Access Compliance Report

Public Rights-of-Way

(Curb Ramps)

Intersection ID: 54229	Main Street: OAKHAVEN_GLEN_LN	Cross Street: PROVIDENCE_RD_WEST	Location: NW
ADA ID: C32A29B8F813	Ramp Type: BlendTrans2	Initial Pass/Fail: Fail	Overall Compliance: No
Severity Score: 10			
Codes/Mitigation Info/Possible Solution		Field Measurements/Component Compliance

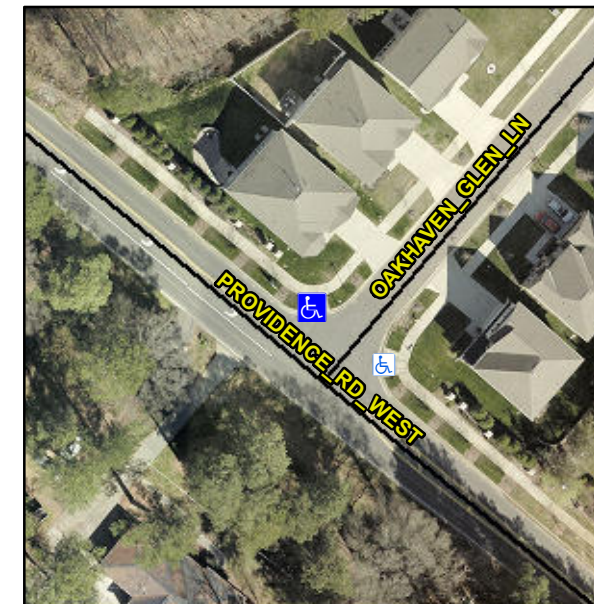
Compliance	Description	Data	Compliance	Description	Data
N/A	Ramp Length (in)	164.0	Yes	BlendTrans Slope (%)	4.1
No	Ramp Width (in)	43.0	No	BlendTrans XSlope (%)	3.0
N/A	Flare Type LT	N/A	N/A	Flare Type RT	N/A
N/A	Flare Slope LT (%)	N/A	N/A	Flare Slope RT (%)	N/A
N/A	Flare Traversable LT?	N/A	N/A	Flare Traversable RT?	N/A
N/A	Landing Length (in)	N/A	N/A	DWS Provided?	N/A
N/A	Landing Width (in)	N/A	N/A	DWS Contrast?	N/A
N/A	Landing Slope (%)	N/A	N/A	DWS Length (in)	N/A
N/A	Landing X Slope (%)	N/A	N/A	DWS Full Width?	N/A
N/A	Landing Curb? (Y/N)	N/A	N/A	DWS Offset (in)	N/A
N/A	Shared Landing?	N/A			
N/A	Gutter Ponding?	N/A	N/A	Gutter Slope (%)	N/A
N/A	Gutter Lip Ht (in)	N/A	N/A	Gutter X Slope (%)	N/A
N/A	Painted X Walk1?	No	N/A	Painted X Walk2?	No
	X Walk 1 Direction	To SW		X Walk 2 Direction	To SE
	X Walk 1 Width (in)	N/A		X Walk 2 Width (in)	N/A
	X Walk 1 Slope (%)	4.5		X Walk 2 Slope (%)	2.3
	X Walk 1 X Slope (%)	1.5		X Walk 2 X Slope (%)	4.2

N/A	Ramp inside XWalk1?	N/A	N/A	Ramp inside XWalk2?	N/A
	Road Slope (%)	1.0		Clear Space?	N/A
	Road X Slope (%)	2.1	N/A	Clear Space to XWalk (in)	N/A
N/A	Any Obstructions?	N/A	N/A	Storm Grate/Utility Hazard?	N/A
	Obstruction Type			Storm Grate/Utility Type	
		N/A			N/A
			Yes	Surface Condition? (G/P)	Good
			N/A	Curb Slope (%)	2.9

Remove & Replace Curb Ramp With Two New Directional Ramps or Equivalent.
